VILLAGE OF BARTLETT
VILLAGE HALL, 228 S. MAIN STREET
COMMITTEE AGENDA
DECEMBER 19, 2023
7:00 P.M.

DATE: December 8, 2023
TO: Kristy Stone, PDS Director
FROM: Daniel Harper, Village Planner 
RE: **(#21-18) Promenade of Bartlett Mixed Use Development**

Final Plat of Subdivision/PUD
Rezoning from B-3 to B-3 PUD
Special Use Permits – Planned Unit Development and carwash
Site/PUD Plan

Acoustic Wall Exhibit

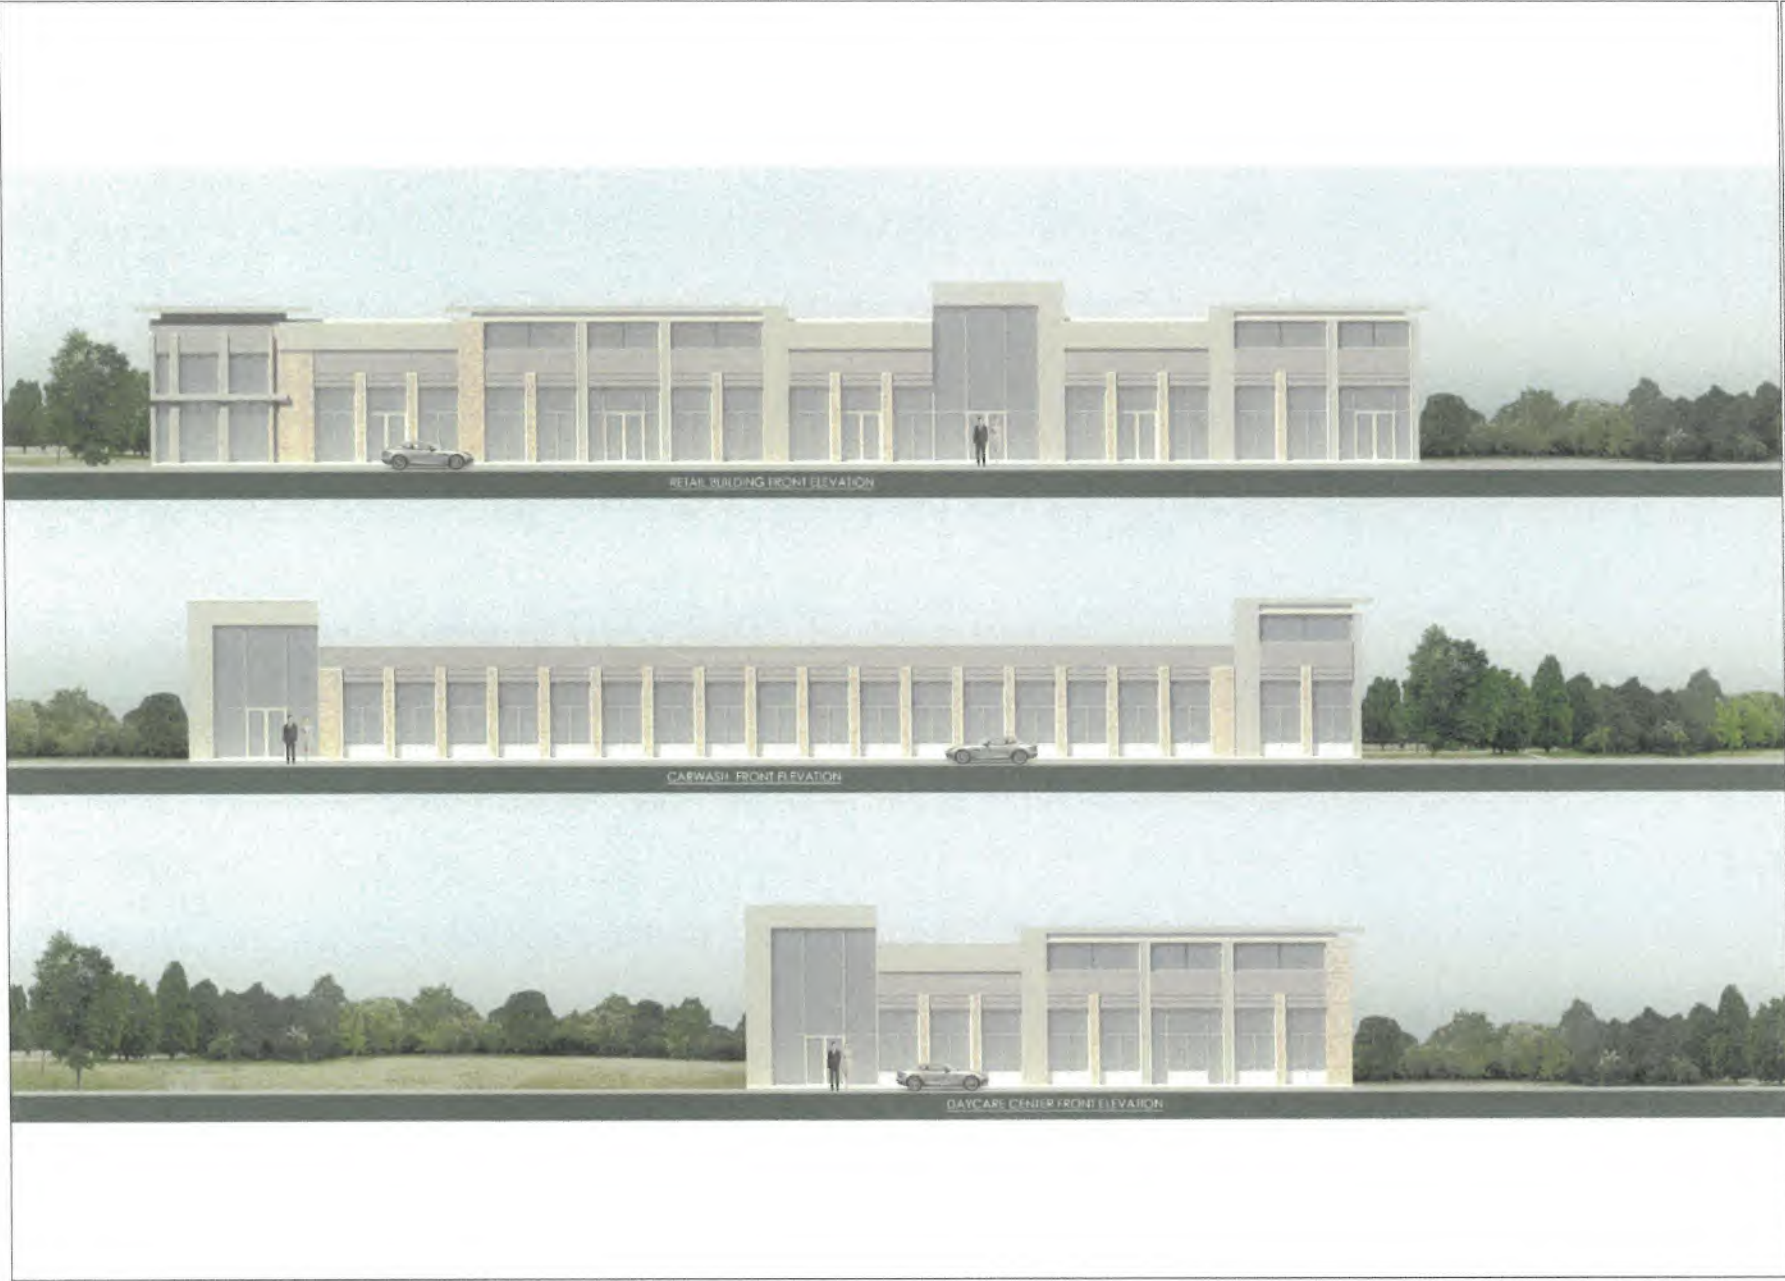
The sound study has suggested that the site include a sound wall located east of the carwash to mitigate noise impacts into the neighboring commercial site to the east. The study stated that the sound wall be:

1. At least 10 feet tall.
2. Approximately 120 feet long.
3. Extend to the ground.
4. Not have any openings
5. Achieve a STC (Sound Transmission Class) of at least 20 db.
6. Must be in the same position as shown on the proposed site plan.

The applicant has modified the proposed site plan and will modify the landscape plan to include a sound wall to screen the carwash exit from the neighboring commercial property. The updated Site Plan is attached for your review.

- C. That a sound wall located east of the carwash be constructed that is at least 10 feet tall, approximately 120 feet long, extends to the ground, does not have any openings, and achieves a STC (Sound Transmission Class) of at least 20 db and must be in the same position as shown on the proposed site plan.

Figure 3 – Sound Level Contours Around the Car Wash for the 6:00 PM Hour

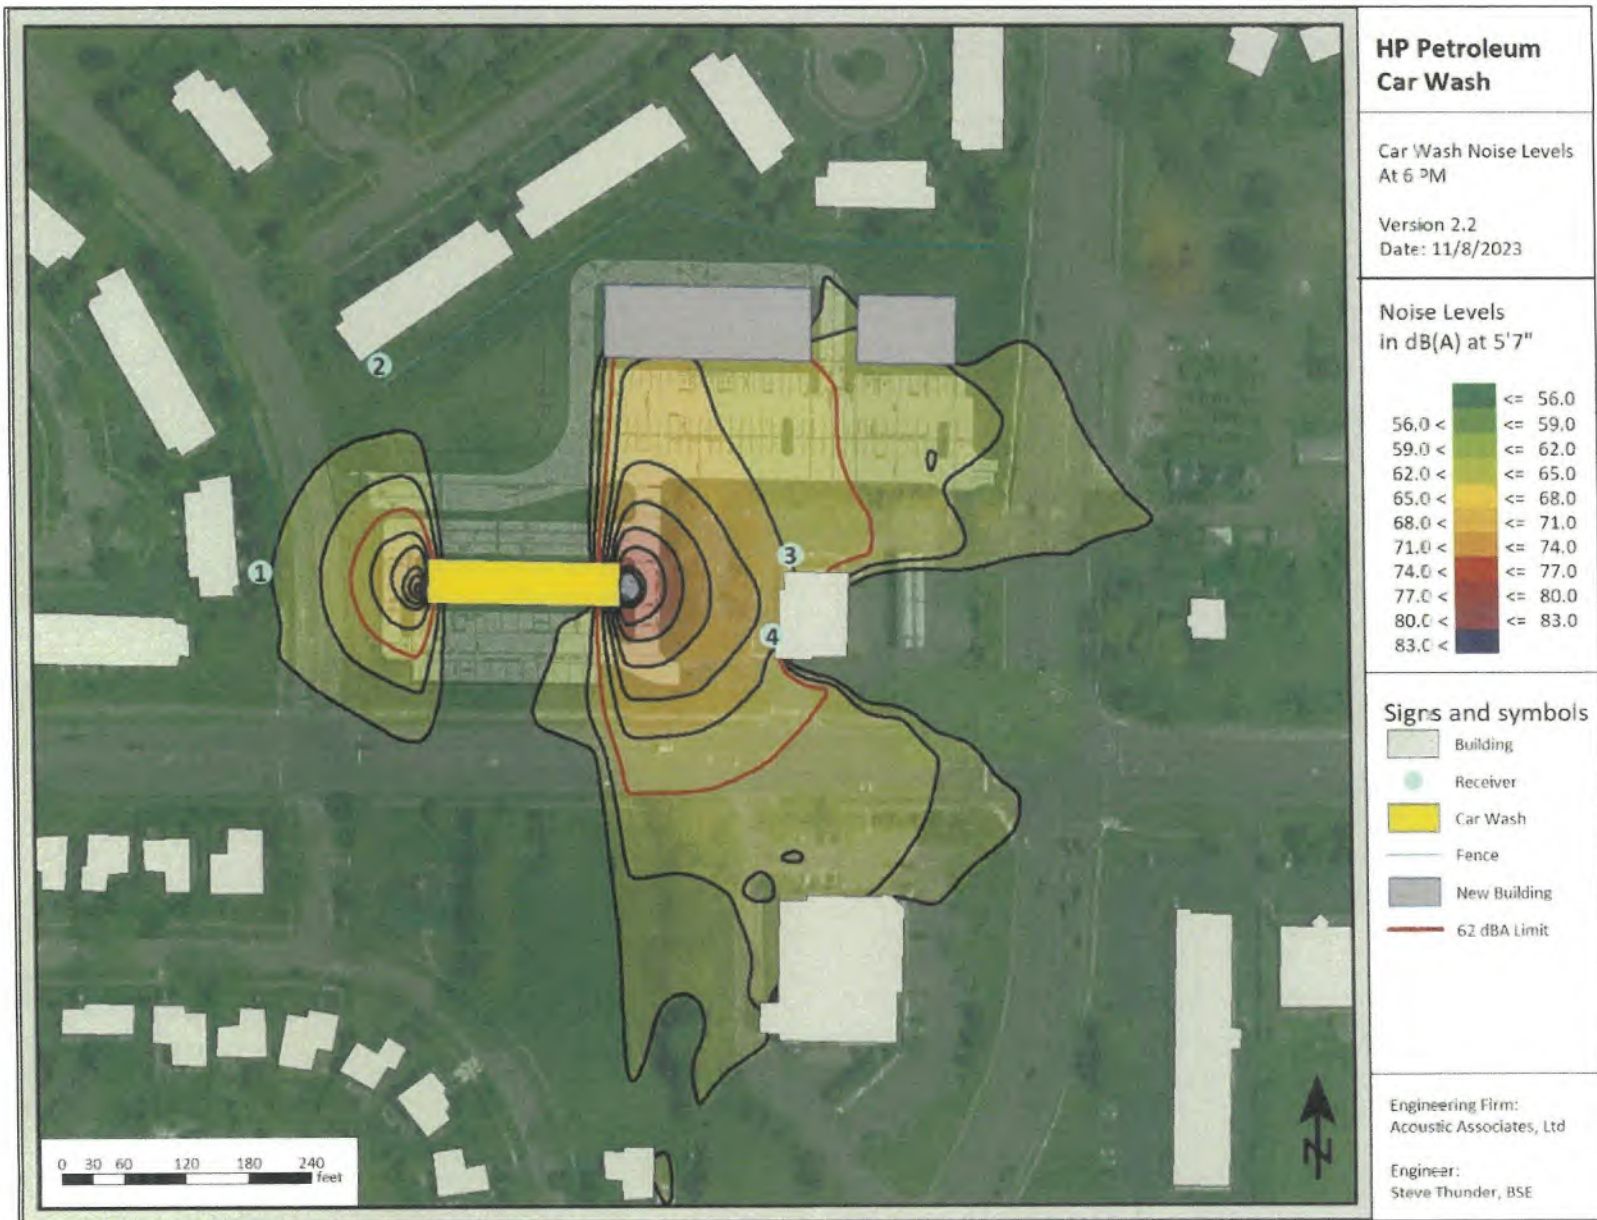
Using our source data and details of the car wash building, the model generated the sound contours as shown in **FIGURE 3**. These contours represent the hourly average of use of the car wash based on the expected volume of vehicles. To visualize these levels compared to the

existing ambient noise, we set the green color on the legend to 56 dB(A), the ambient noise level at the site between 6 PM and 7 PM (the time of maximum car washes). Each contour line represents a change of 3 dB; an amount chosen because it represents a “just noticeable” change to the human ear (see Table 1). The blue dots are virtual receiver locations that we chose to look at in more detail.

While **FIGURE 3** shows the radiation of sound from the car wash, **FIGURE 4** shows the hourly LEO of the car wash noise compared with the hourly L50 ambient sound levels. The ambient sound levels each hour are shown by the green line. The blue bars are the sound levels from the car wash at location #1 (the backyard of 113 Longford Rd). Each blue bar also lists the estimated number of car washes for each hour. This is a heavy-use estimate based on general car wash patterns and the owner's estimate of 8-10 car washes per hour. During some hours the car wash noise is projected to be above the 55 dBA limit and ambient noise, therefore noise mitigation will be needed.

Figure 6 – Sound Level Contours with a Sound Wall

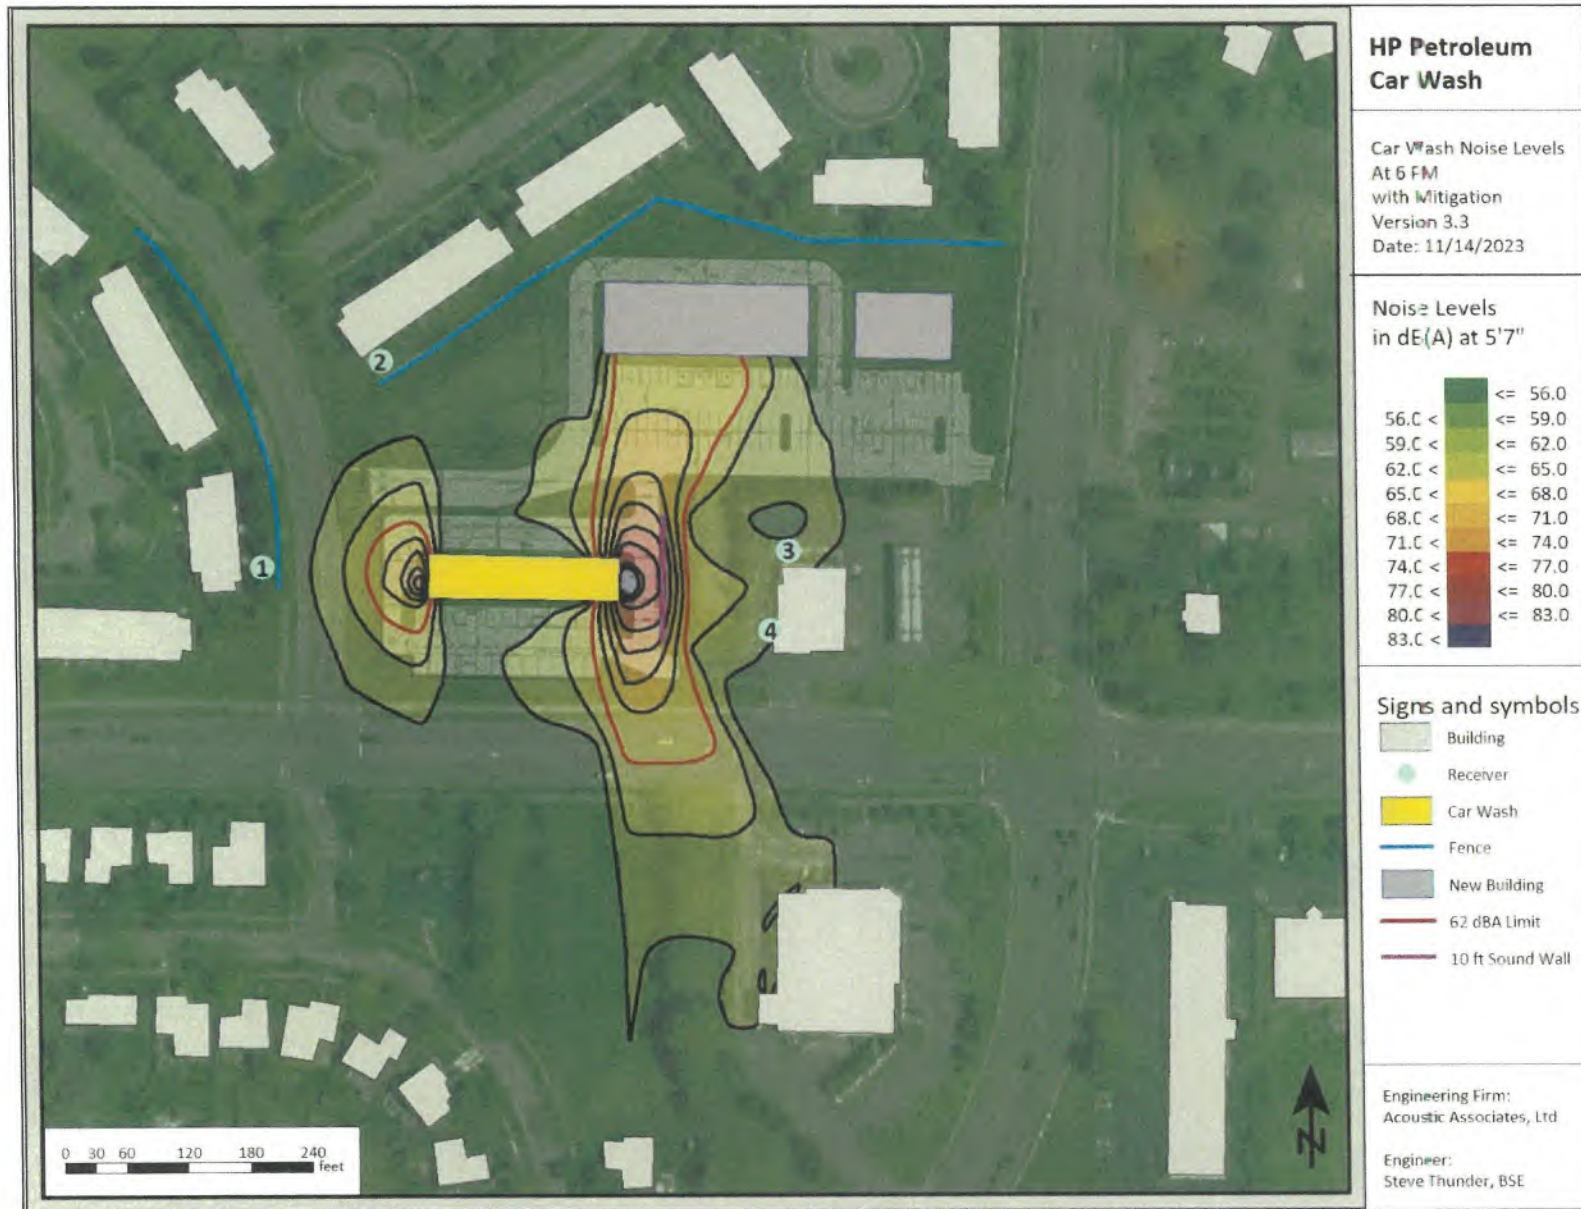
Because the car wash noise was found to be higher than some limits, we also modeled the sound levels with mitigation, i.e., the addition of a sound wall at the exit (east side of the car wash). Also included is sound absorption inside the car wash and on the sound wall. This wall is shown as a purple line in **FIGURE 6** (the sound wall is just east of the car wash; the blue lines near homes are existing fences). **FIGURE 6** shows the sound levels with the sound wall compared to the existing ambient noise. We set the green color on the legend to 56 dB(A), the ambient noise level at the site between 6 PM and 7 PM (the time of maximum car washes). Each contour line represents a change of 3 dB; an amount chosen because it represents a “just noticeable” change to the human ear (see Table 1). The blue dots are virtual receiver locations that we chose to look at in more detail. Location #3 is the drive-thru speaker location and Location #4 is the drive-thru window.

- 1) The sound wall,
 - a. Must be at least 10 feet tall.
 - b. It should be approximately 120 feet long.
 - c. It must extend to the ground.
 - d. It must not have any openings.
 - e. It must achieve an STC (Sound Transmission Class) of at least 20 dB (loss of sound going through it).
 - f. It must be in the same position we have shown in Figure 6 (~3 ft from the curb)
- 2) The sound wall must have an absorptive side facing the car wash with a minimum of 0.80 NRC (Noise Reduction Coefficient). This can be accomplished with absorptive masonry, such as Sound Seal’s RSC SoundBlox; a traditional wall lined with sound absorption panels; or a metal panel wall with an absorptive side, such as Noise Barriers QuietLine® Barrier Walls.
- 3) 500 square feet of sound absorption panels must be installed inside the car wash with a minimum of 0.95 NRC.

The sound wall effectively reduces the noise from the car wash to less than 62 dBA for the Dunkin/gas station. The level is above 62 dBA for the new building north of the car wash, but this building is part of this construction project and there isn’t a sensitive area affected by the noise. Although, I do recommend using higher noise-reduction windows and doors on the front of this building when it’s constructed.

Figure 8 – Ambient and Car Wash Sound Levels with Mitigation by Hour

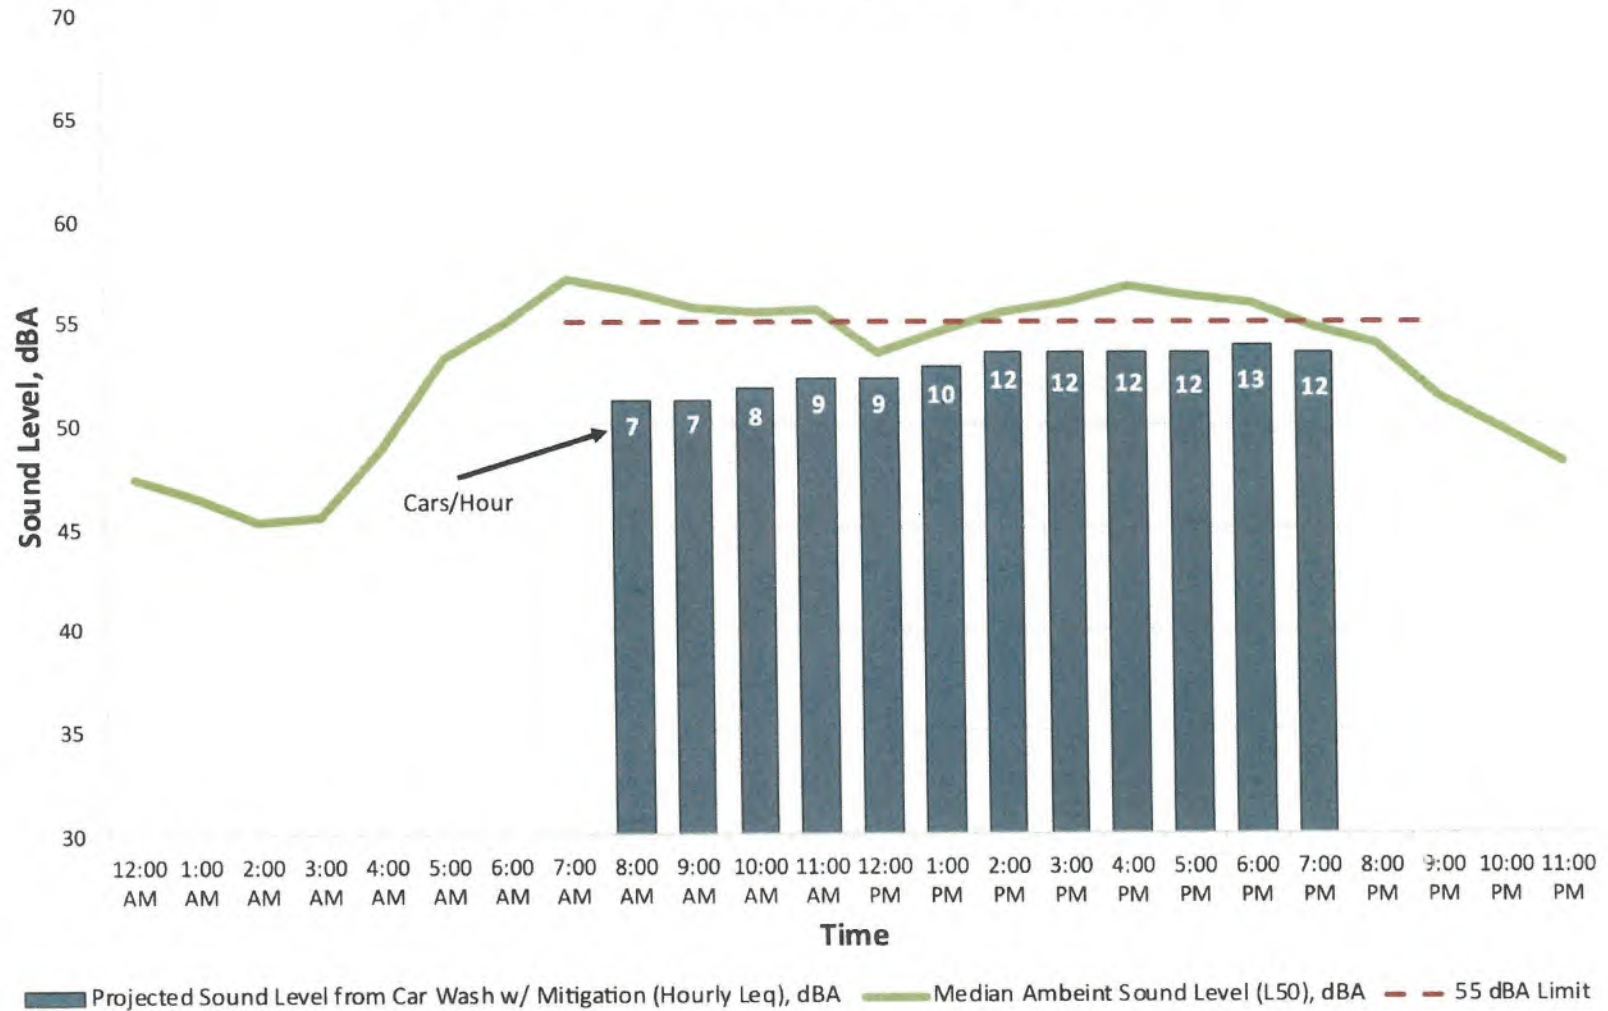
FIGURE 8, is the same as **FIGURE 4** but with the mitigation specified above. It shows for each hour the car wash is open, the hourly average noise from the car wash will be below the 55 dBA limit and below the ambient noise.
